P5003A-03

# Information Only Service Note

# P5003A Keysight Streamline USB Vector Network Analyzer

False alarm on self-test failure on firmware revision of A.13.40.02 - DDR3 memory removal

#### Self-test

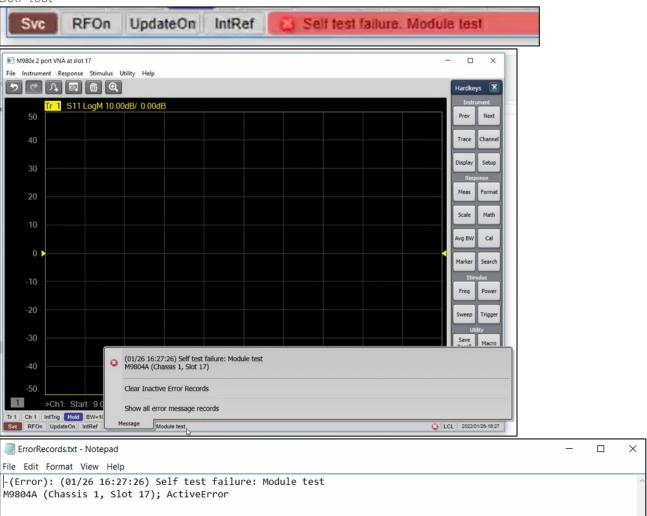
The on board DDR 3 memory in VNA is not in use since its release. With the removal of DDR 3 memory IC on newer P500xA VNA, right after firmware is launched, false alarm (self-test failure) will be reported as shown. This has no impact to VNA performance and specifications.

Similarly, firmware will report a false failure in Operator check. Shown are the error messages example on VNA firmware UI.

For users with firmware revision of A.13.40.02, Update firmware to revision A.13.70.02 or newer to resolve this false alarm on self-test.
